PROJECT: Falcon Marketplace
 PROJECT NO: 20988-00CSCV
 DESIGN BY: KGV
 REV. BY: TDM
 AGENCY: El Paso County
 REPORT TYPE: Preliminary
 DATE: 8/31/2018

FALCON MARKETPLACE

EXISTING DRAINAGE CONDITIONS

PROPOSED DRAINAGE CONDITIONS

ED-1

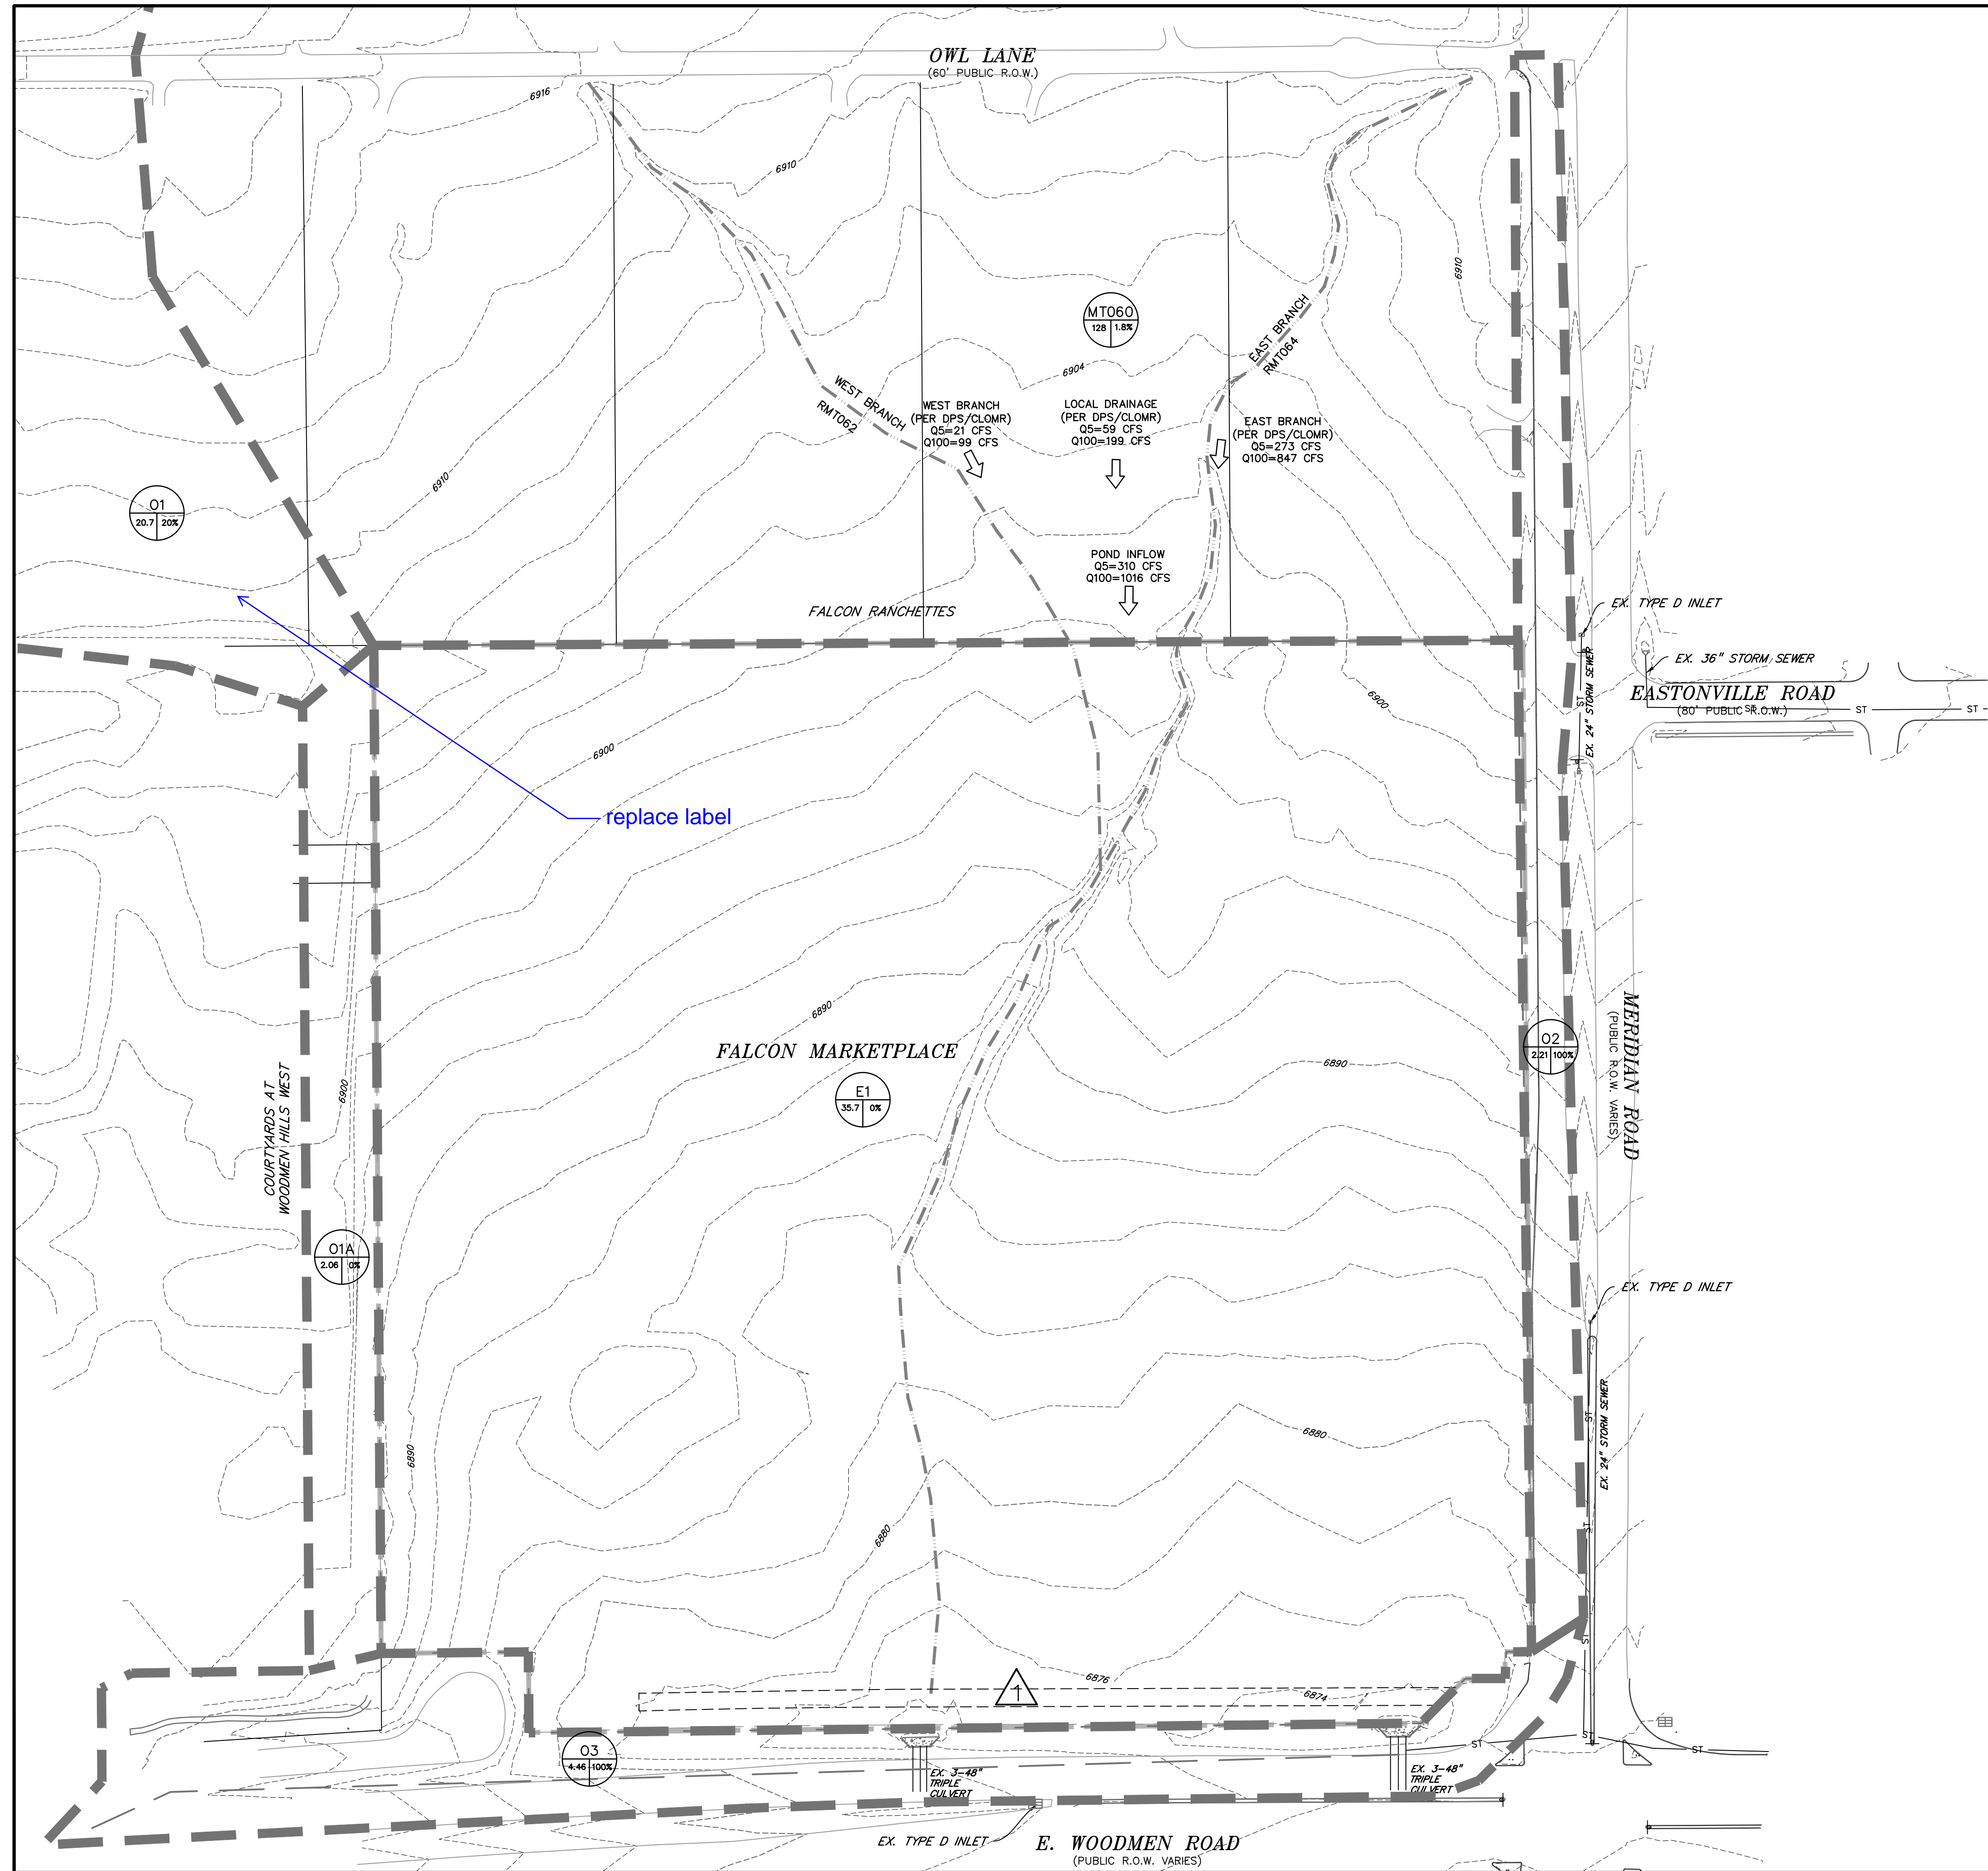
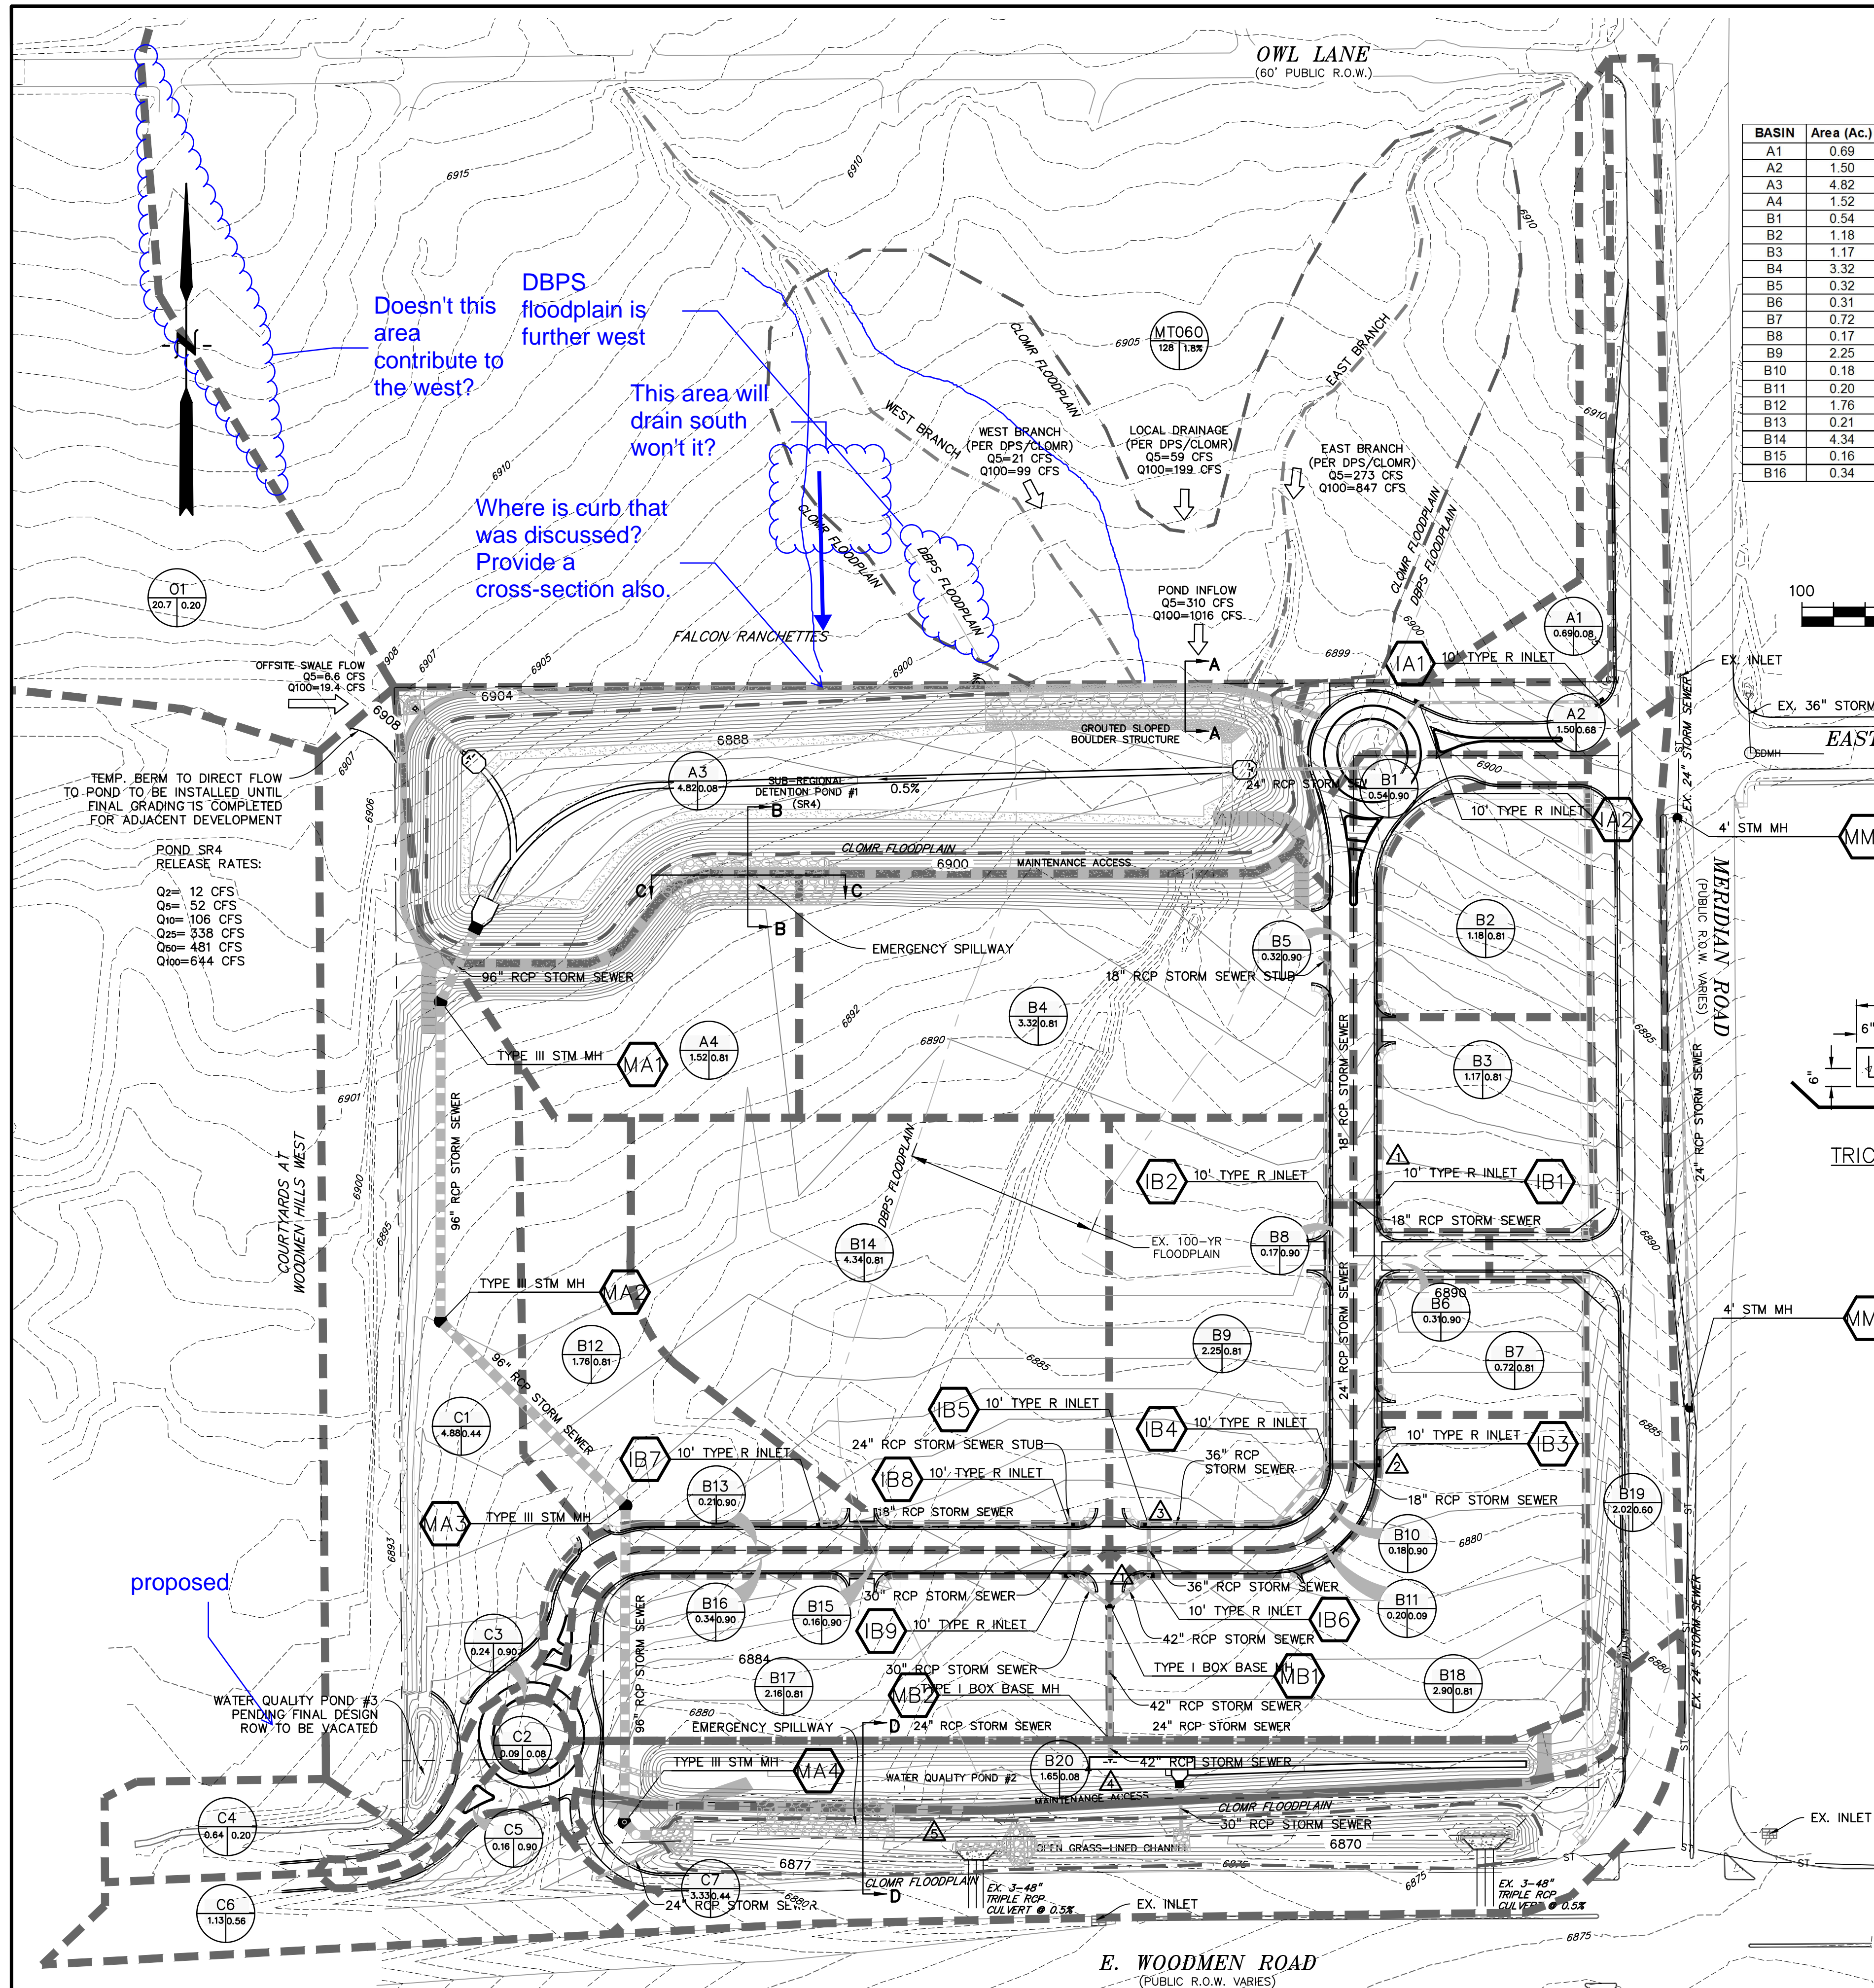
Show and label all offsite sub-basins.

Show existing FEMA floodplain and DBPS floodplain.
